STAFF REPORT: JULY 8, 2020 MEETING

APPLICATION NUMBER: 20-6773

ADDRESS: 4125 SECOND

SCOPE OF WORK: ERECT EXTERIOR STAIR SYSTEM AT REAR OF BUILDING

NEW EXTERIOR STAIR PLAN A-3

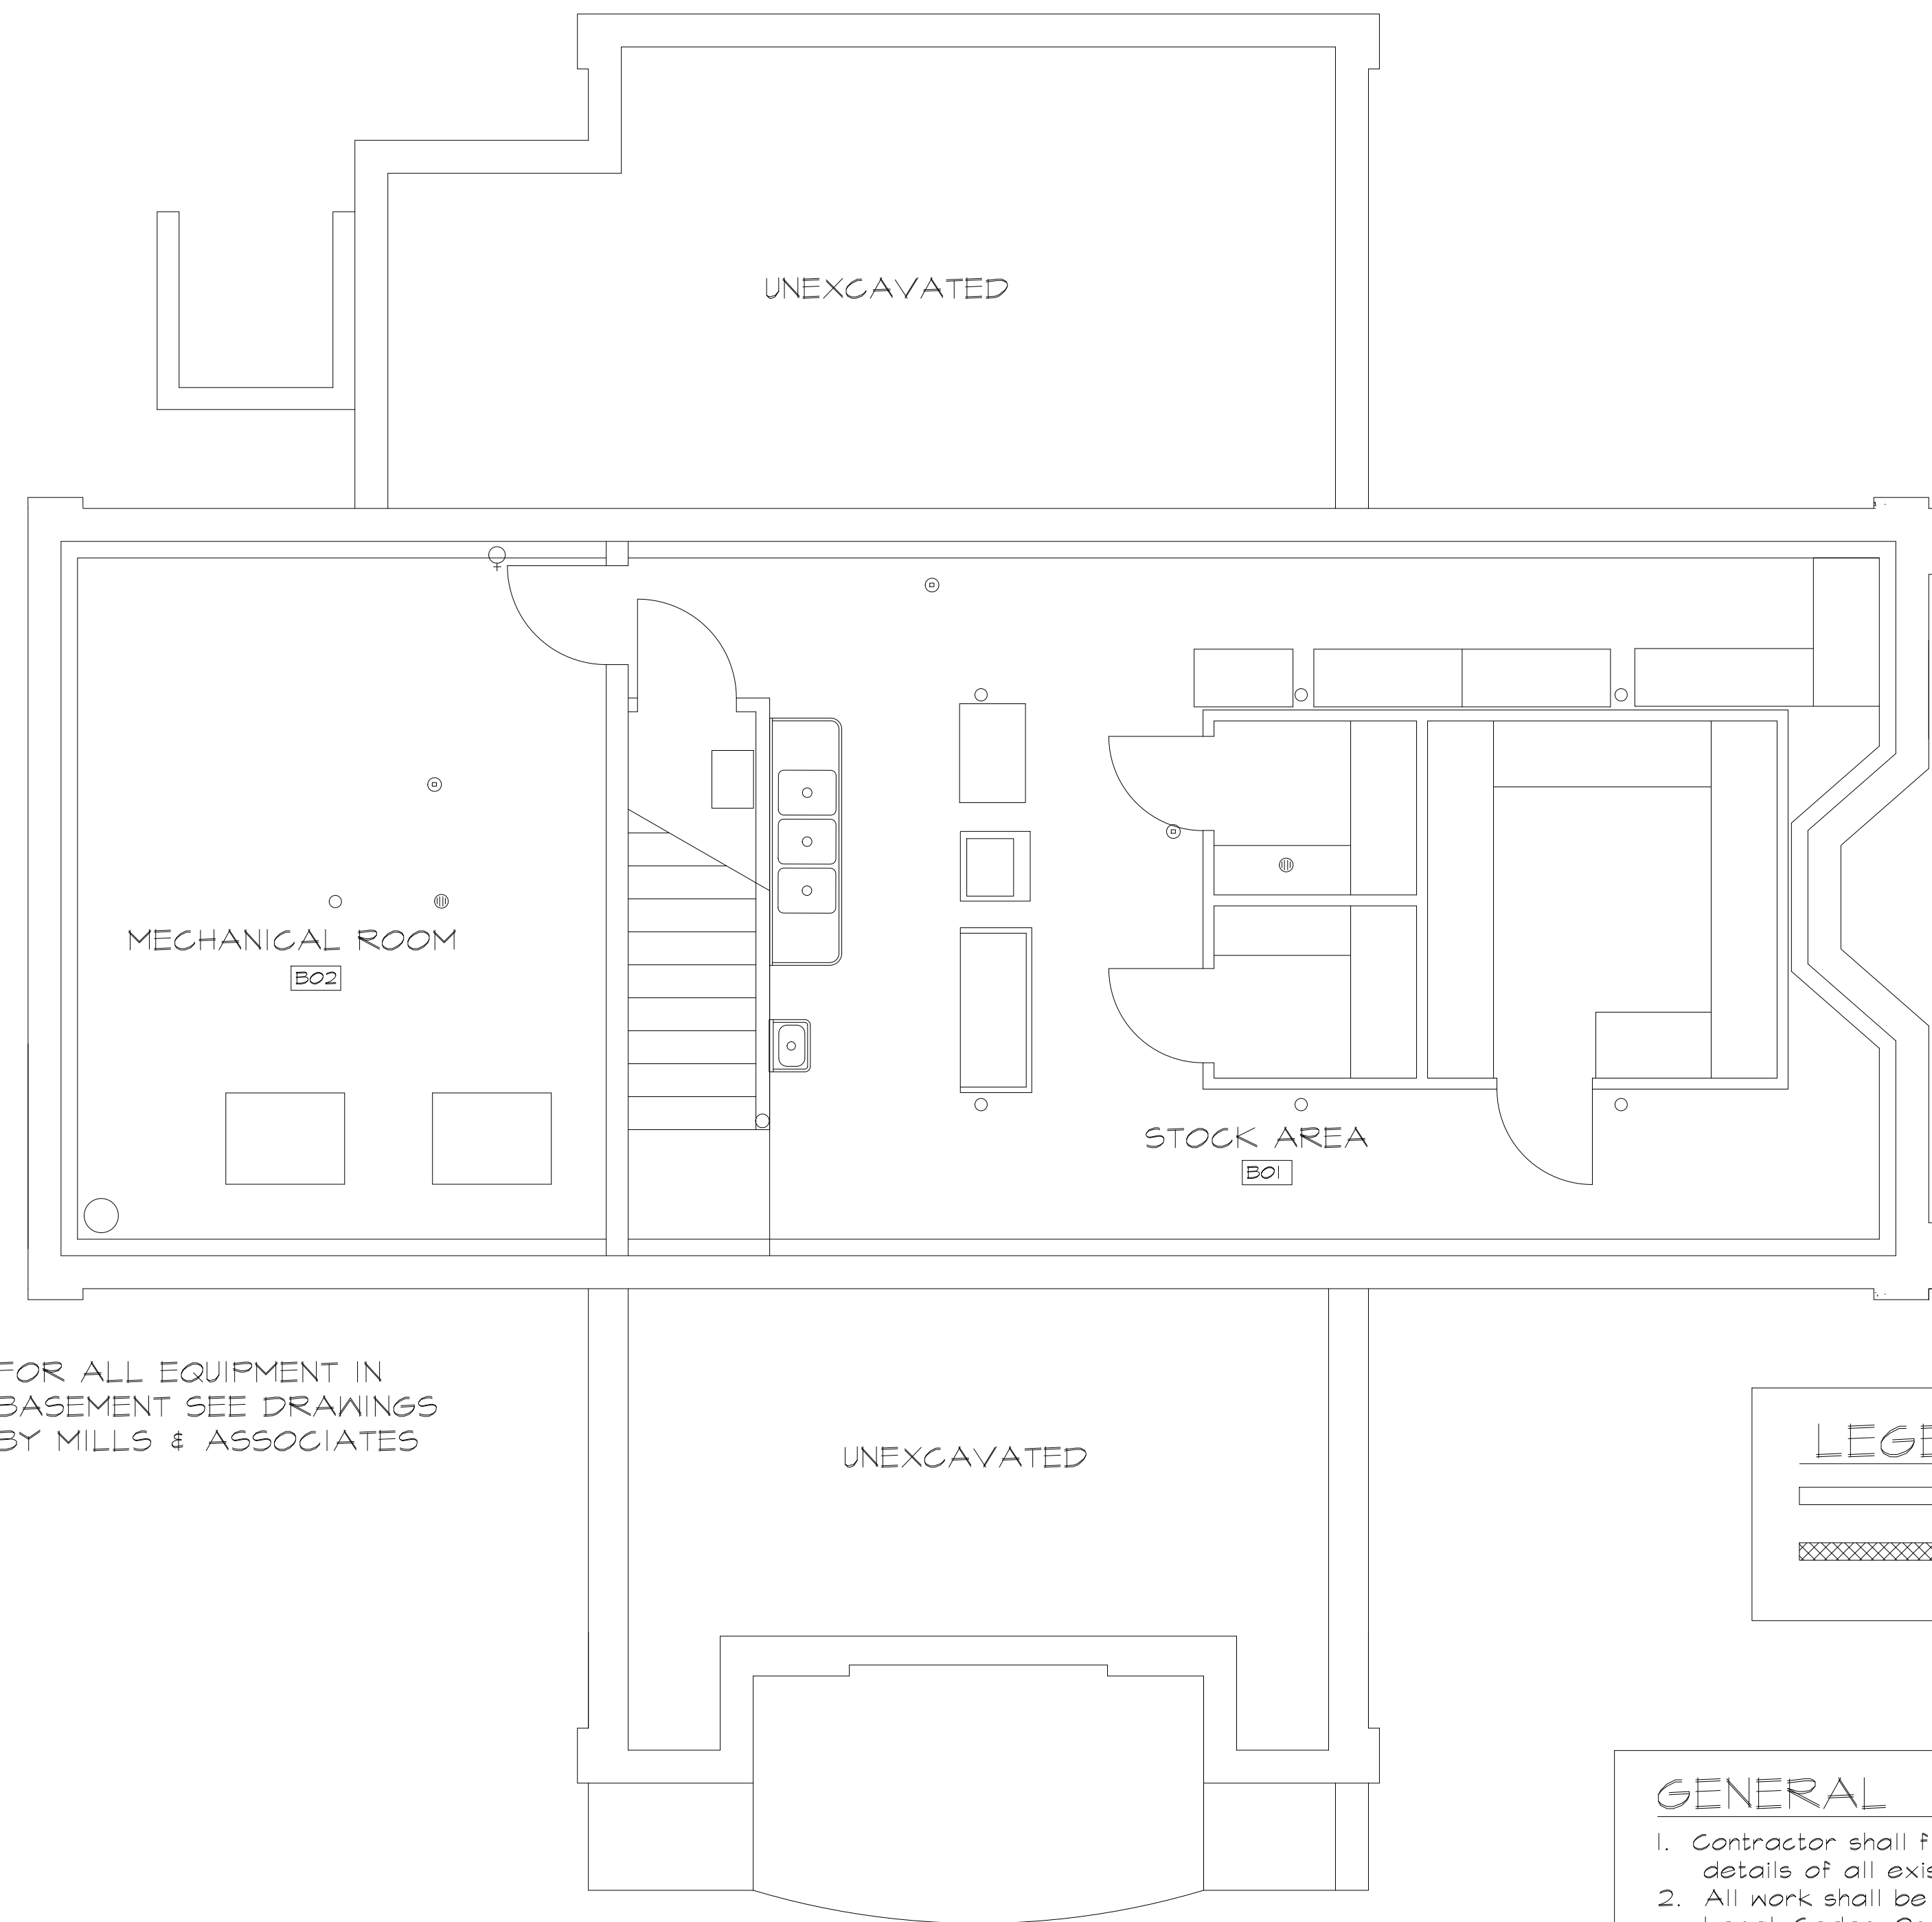
- **Location:** The staircase will be located at the rear of the building, not visible from Second Ave. The staircase might be visible from W. Alexandrine, however, from a distance. It is staff's opinion that the addition will not detract from the building or the Willis-Selden HD.
- **Exterior Modification:** The staircase will require slight modifications to the existing parapet and pergola, neither of which are historic age materials. It is staff's opinion that selected materials for the staircase are appropriate and the overall impact will not detract from any character defining features of the building or the Willis-Selden HD.

- **Addition of New Staircase:** Staff recommends that the Commission issue a Certificate of Appropriateness for the proposed work based on Secretary of the Interior’s Standards for Rehabilitation.
